Office Action Summary

10/568,787

EMBLIN, ALAN GAYNE

DETAILED ACTION

Fig. 3: Durbin (US 4,254,932)

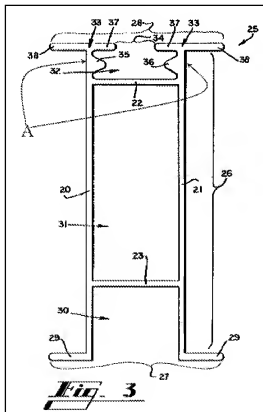
With regards to claims 60, 63, and 68: Durbin discloses a stud (25) capable of use in panel form work for solid filled walls, the stud comprising:

a head (22) formed as a strip (fig. 1) capable of being bonded and/or fastened to an inner face of a panel facing sheet, and

a pair of spaced, opposed flanges (A) formed along and extending away from a central portion of the head (22) the flanges defining a recess (32) with inwardly directed teeth (37) capable of engagement of a spacer element. Examiner notes the central portion of the stud/base is interpreted to be the middle portion along the longitudinal length of the stud.

The recess of Durbin is capable of allowing passage of a suitably dimensioned spacer element, wherein the recess deforms the flanges and causes the inwardly directed teeth to engage the spacer element. Note that any solid material would inherently be able to elastically/plastically deform to certain degree before failure.

With regards to claim 61: Durbin discloses the width of the head (20-21, 23, 29) is substantially greater than the spacing of the teeth (37) of the flanges on the central portion of the head.

With regards to claim 65: Durbin discloses two or more teeth (35-37) extending longitudinally along each flange (A) inside the recess (fig. 3).

With regards to claim 66: Durbin discloses each flange (A) has an out-turned terminal lip (38) (fig. 3) capable of guiding passage of the spacer element into the recess.

With regards to claim 67: Durbin further discloses the head, flanges and teeth are formed integrally as an extrusion (fig. 3). Note that head, flanges and teeth being formed from extrusion is considered product by process.

Fig. 3A: Dunn et al. (US 2002/0124508 A1)

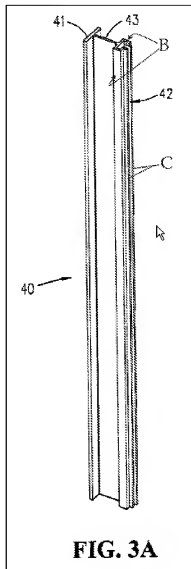
With regards to claims 60, 63, and 68: Dunn et al. discloses a stud (40) capable of use in panel form work for solid filled walls, the stud comprising:

a head (41) formed as a strip (fig. 3A) capable of being bonded and/or fastened to an inner face of a panel facing sheet, and

a pair of spaced, opposed flanges (B) formed along and extending away from a central portion of the head (41), the flanges (B) defining a recess with inwardly directed teeth (inwardly turned flanges) capable engagement of a spacer element.

The recess of Dunn et al. is capable of allowing passage of a suitably dimensioned spacer element, wherein the recess deforms the flanges and causes the inwardly directed teeth to engage the spacer element. Note that any solid material would inherently be able to elastically/plastically deform to certain degree before failure.

With regards to claim 62: Dunn et al. discloses the width of the head (41) is approximately seven times the spacing between the teeth (inwardly turned flanges) of the flange on the central portion of the head.

With regards to claim 64: Dunn et al. further discloses a cross sectional configuration, formed by the strip and the pair of flanges, which is substantially T-shaped (fig. 3A).

With regards to claim 66: Dunn et al. discloses each flange has an out-turned terminal lip (C) capable of guiding passage of the spacer element into the recess.

With regards to claim 67: Dunn et al. further discloses the head, flanges and teeth are formed integrally as an extrusion (fig. 3A). Note that head, flanges and teeth being formed from extrusion is considered product by process.

With regards to claim 71: Dunn et al. further the width of the head of each stud is more than double the width of the recess formed by the teeth of the flanges (figs. 1B & 3A). Note that the teeth are part of the flanges.
